CITY OF ELBERTON**SPLASH PAD FACILITY**

Engineer's Project No. 448-10A

ADDENDUM NO. 2

January 10, 2025

BUILDING PLUMBING & FIXTURES

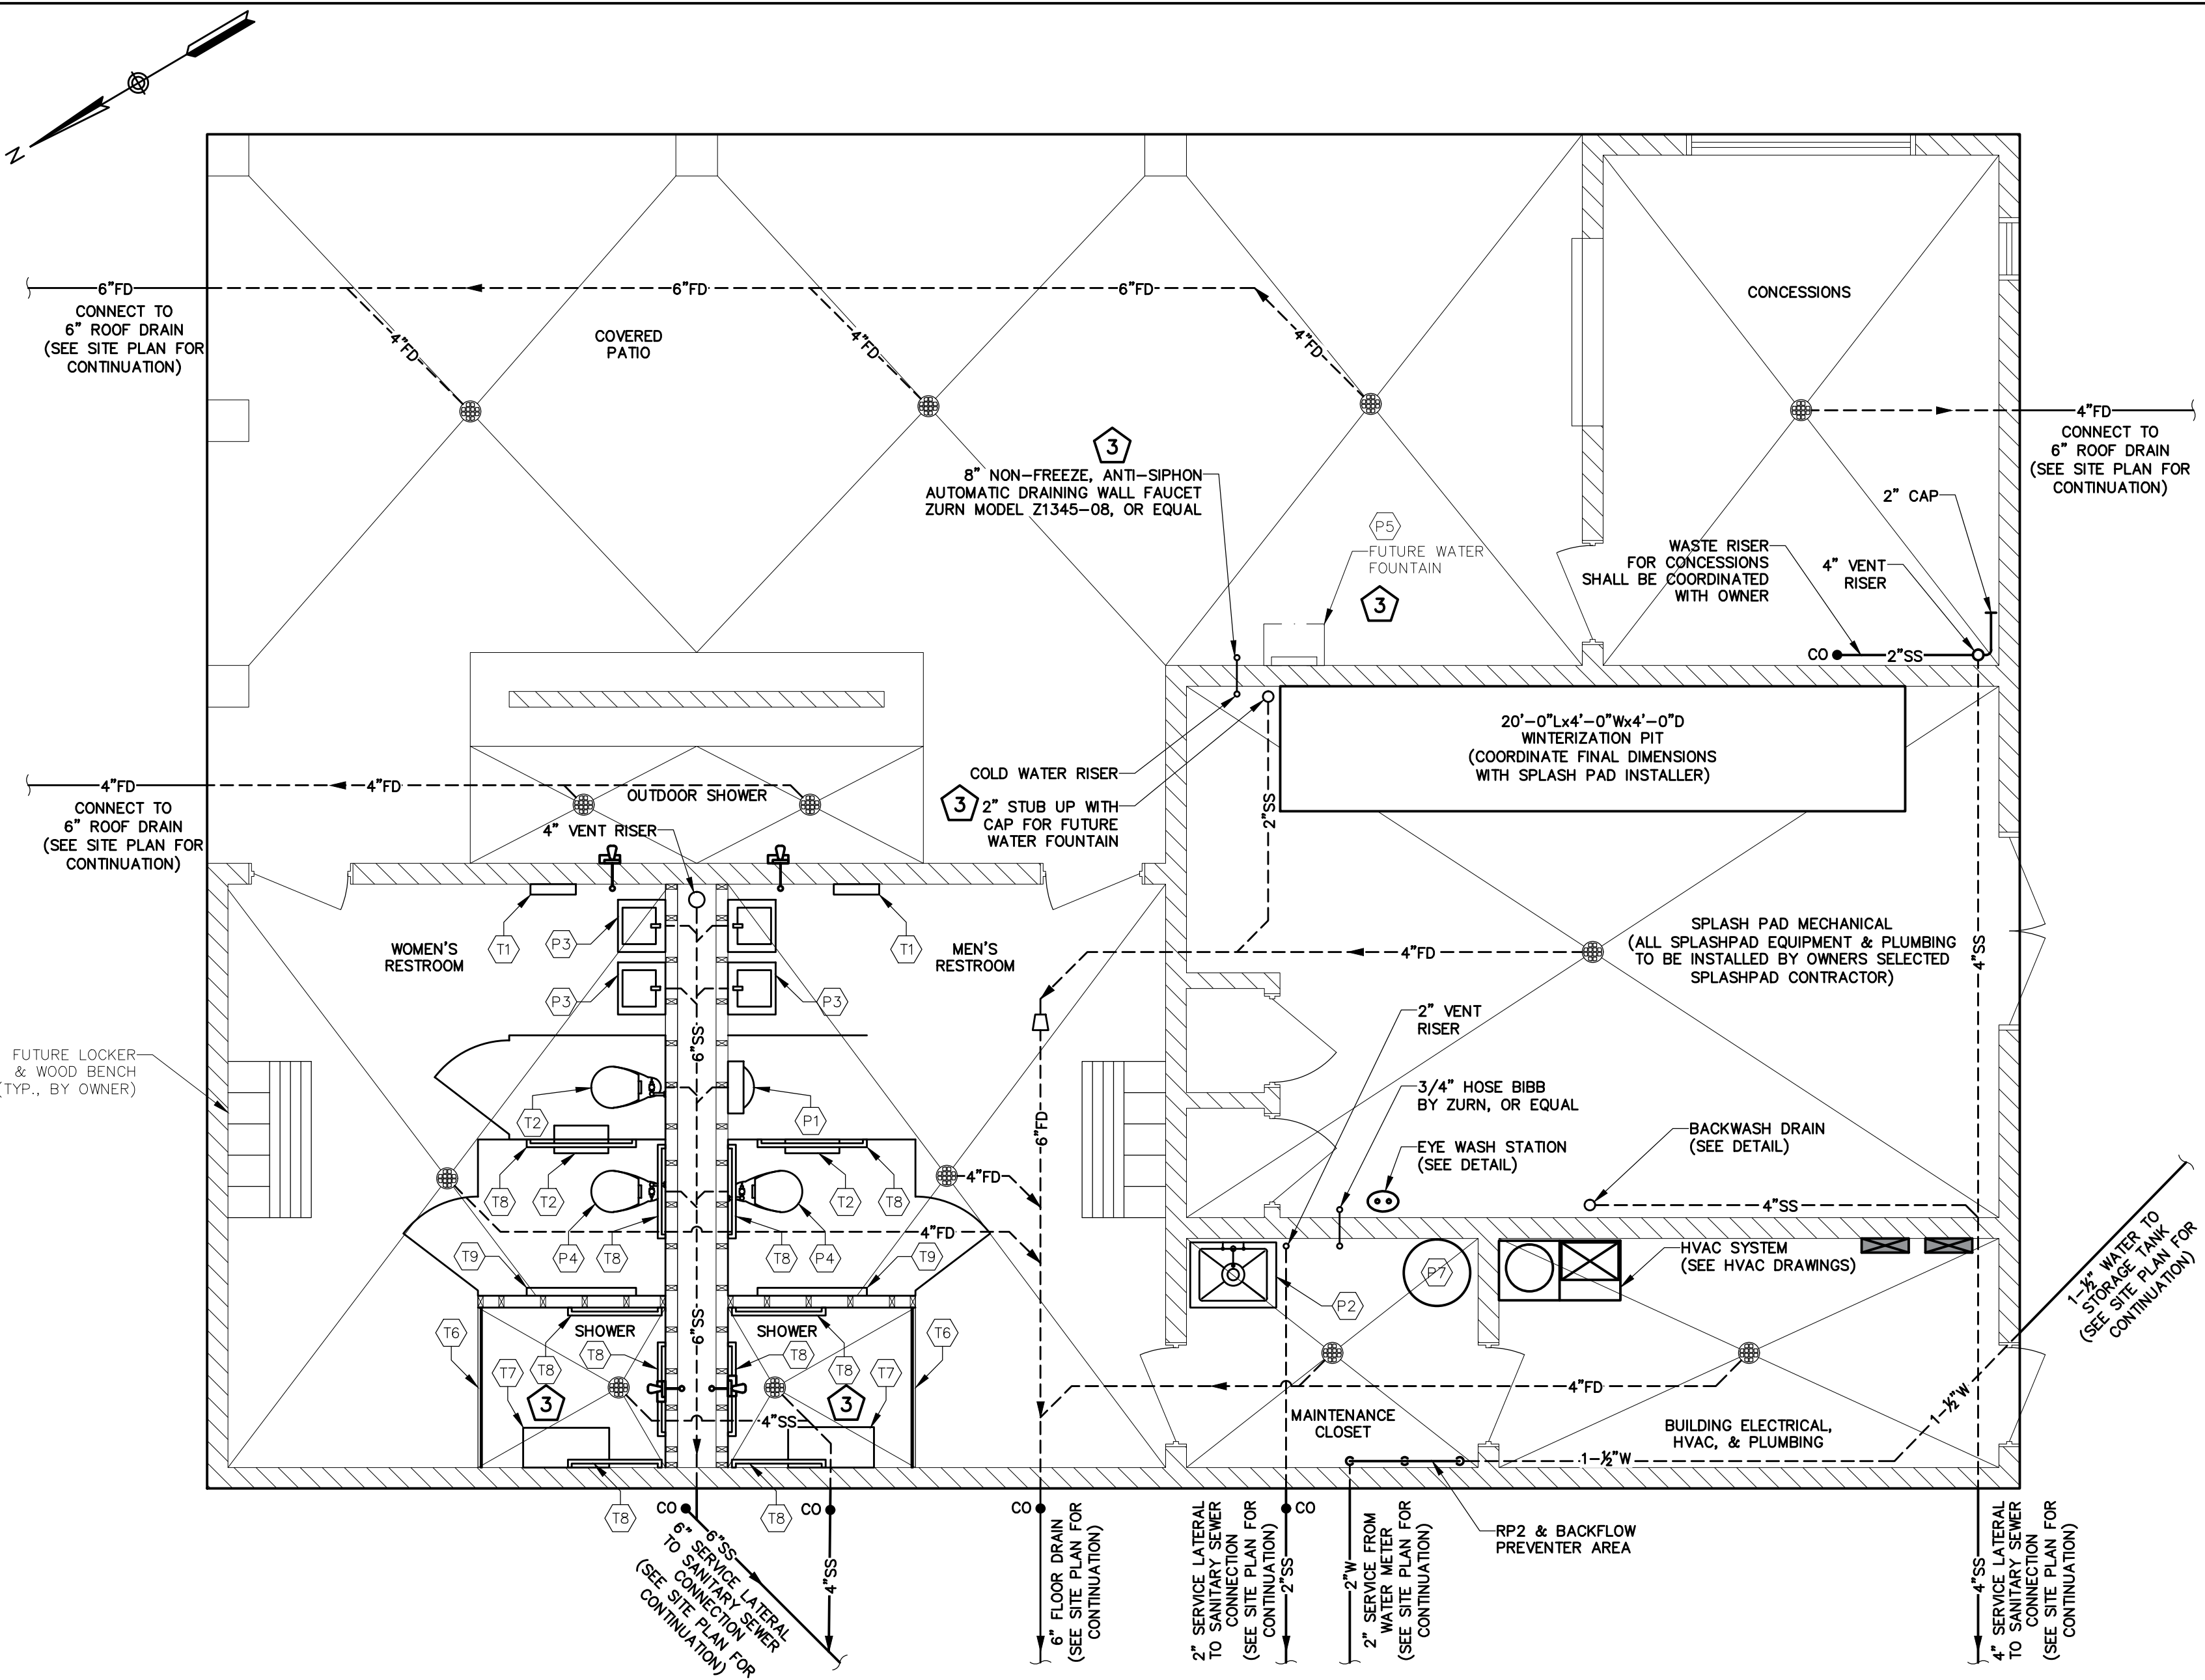
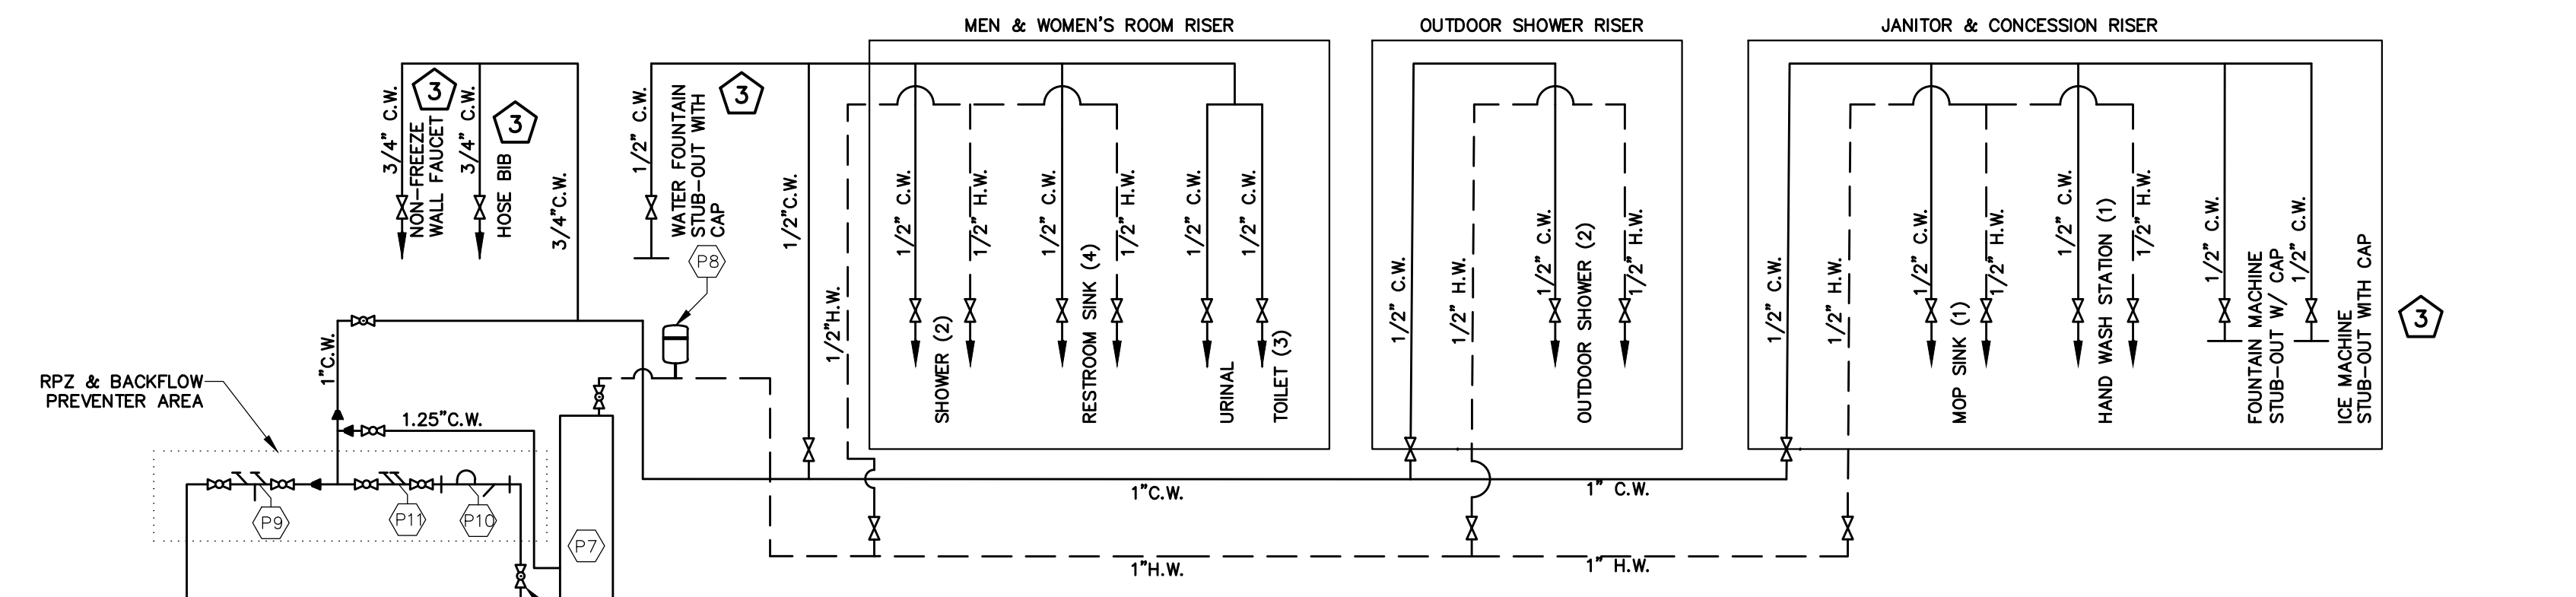
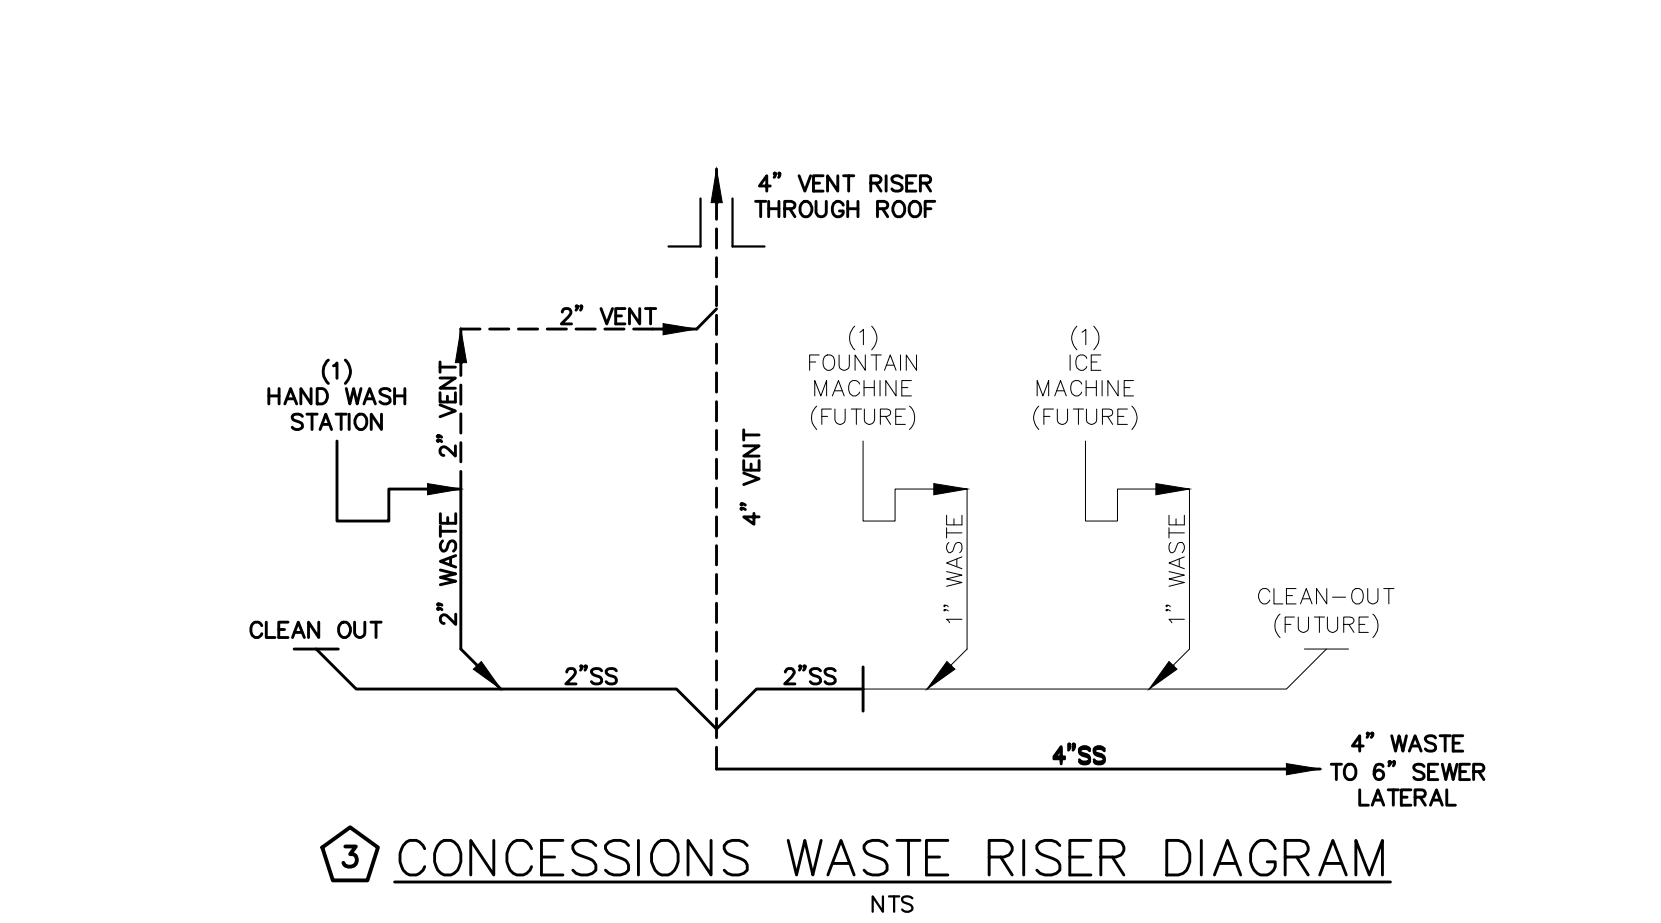
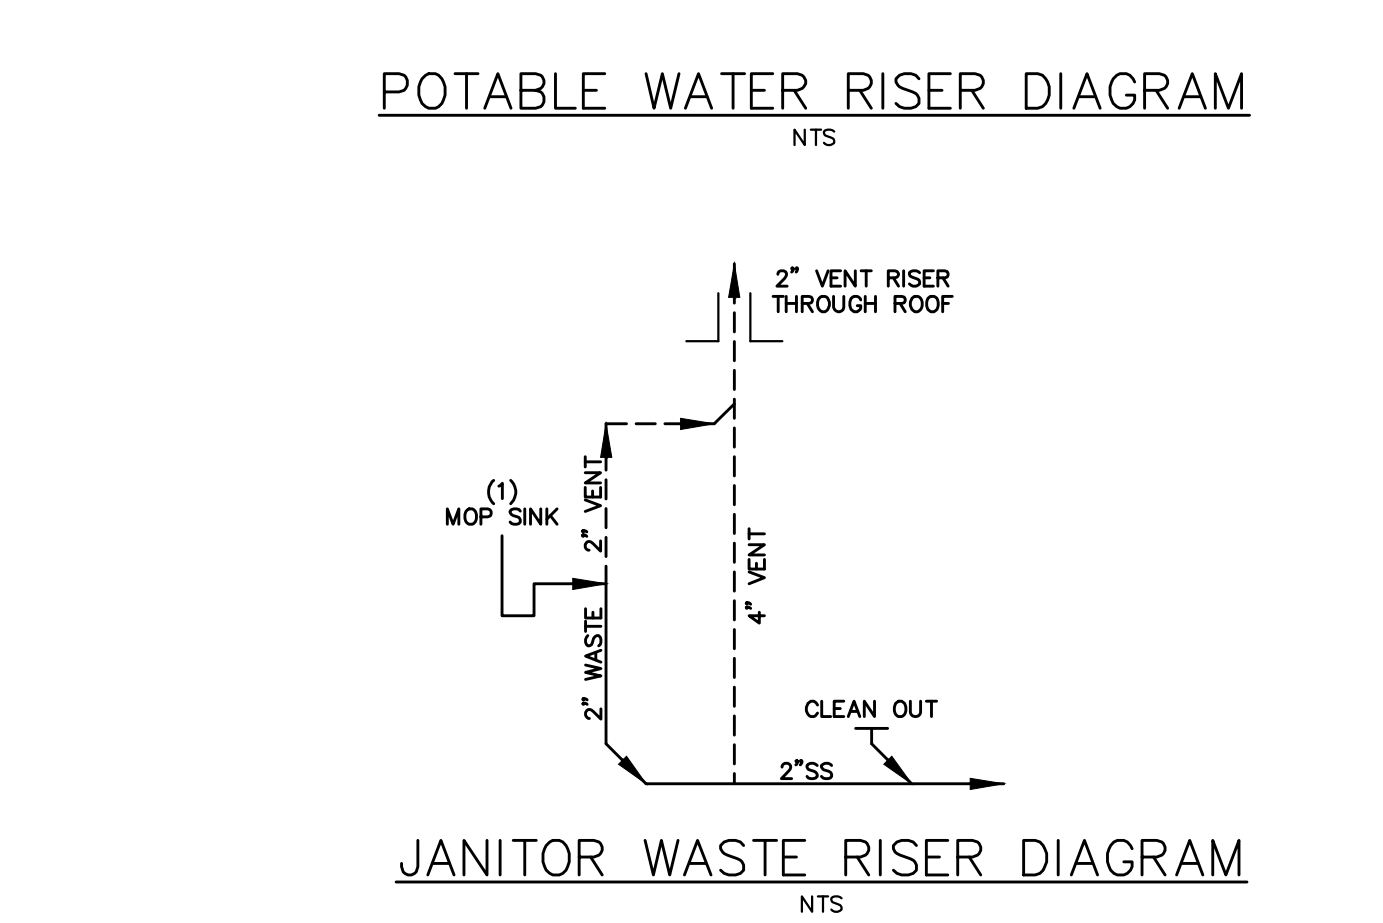
2. Page 16 does not show a drain in the pit. Will this be required?

6. Page 16 does not show a water fountain. Is one required?

- Fire panel location should be coordinated with the Owner. See construction notes on sheet 16.***
14. PL400 shows an eye wash station and states "by plumber." However, drawing 16 (plumbing) does not indicate an eye wash or a water line to supply it. Will an eyewash station and water line be required?

- Yes, an eye wash station with water line is required, see detail on sheet 16.***
15. PL403, Detail 6, shows a floor drain and instructions that are not indicated on the plumbing drawings. Will clarification be provided?

- See drain detail on sheet 16.***
16. PL403, Detail 6, needs a determination for the size of the drain line. What size is required?
- The drain line should be 4". See sheet 16.***

18. Will grab bars be required in the showers?
- Grab bars have been added to the three walls of the interior shower units, as shown on Sheet 16.***

22. There is no hose bib in the mechanical room. Will one be required?

No drain is required in the pit. The pit is sloped down at a rate of 0.125" per foot to facilitate the use of a sump pump per call out on sheets 13 and 14.

A stub out and valve should be installed on the waterline for future connection per callout on sheet 16.

See updated drawings on sheet 16.
